PROJECT PROPOSED DISTRICT PLAN: REZONING SUBMISSIONS: LINCOLN PACKET
SUBJECT PEER REVIEW OF TRANSPORT MATTERS
TO JUSTINE ASHLEY, VICKI BARKER
FROM MAT COLLINS
REVIEWED BY BRONWYN COOMER-SMIT
DATE 20 DECEMBER 2022

SUMMARY OR PEER REVIEW

Figure 2: DPR-0136 subject sites

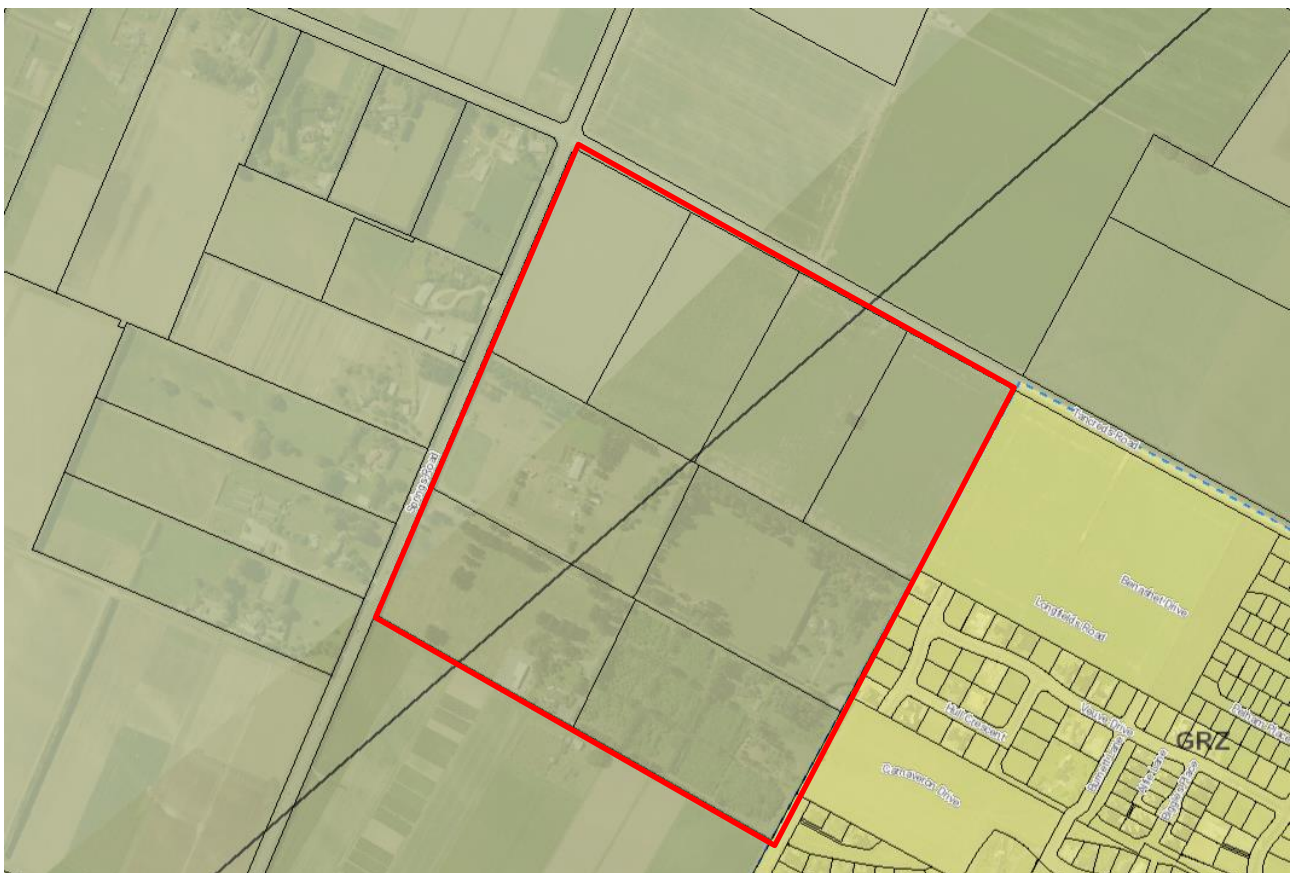
- ♦ I agree with Mr Rossiter that
 - The proposed rezoning will likely lead to an increased incidence of crashes at Springs/Tancreds and Springs/Boundary if the current intersection forms are retained

- The intersections of Springs/Tancreds and Springs/Boundary should be upgraded to roundabouts, to support the rezoning and address potential safety effects

- Council's proposed signalisation of the Springs/Ellesmere Junction intersection will support the rezoning
- ♦ Mr Rossiter notes that third party land would be required to construct a roundabout at the Springs/Boundary intersection, but that traffic signals could be constructed instead. However, it is not clear whether there is sufficient width available within the Springs Road and Boundary Road corridors to form a signalised intersection, as this would likely require a multi-laned arrangement due to the high traffic volumes. Further, in my view traffic signals are unlikely to be appropriate in terms of safety and legibility of the Springs Road corridor in what would be a predominately rural location

- ♦ I agree with Mr Rossiter that the Springs/Tancreds and Springs/Boundary intersections should have safety improvements to support the rezoning and address potential safety effects
- ♦ However, there is uncertainty about the feasibility, timing and responsibility for delivering these intersection upgrades. Further, in my opinion traffic signals (as an alternative suggested by Mr Rossiter) would not be an appropriate solution for the predominantly rural location
- ♦ While I support Mr Rossiter's recommendation that the speed limit on Springs Road be reduced, this may not be feasible as the proposed zoning essentially creates an urban "island" that is separated from the Lincoln urban area by approximately 2km of rural zoning
- ♦ I therefore recommend that the rezoning request be declined
- ♦ Should Council accept the rezoning, I recommend that the ODP and ODP narrative be amended to
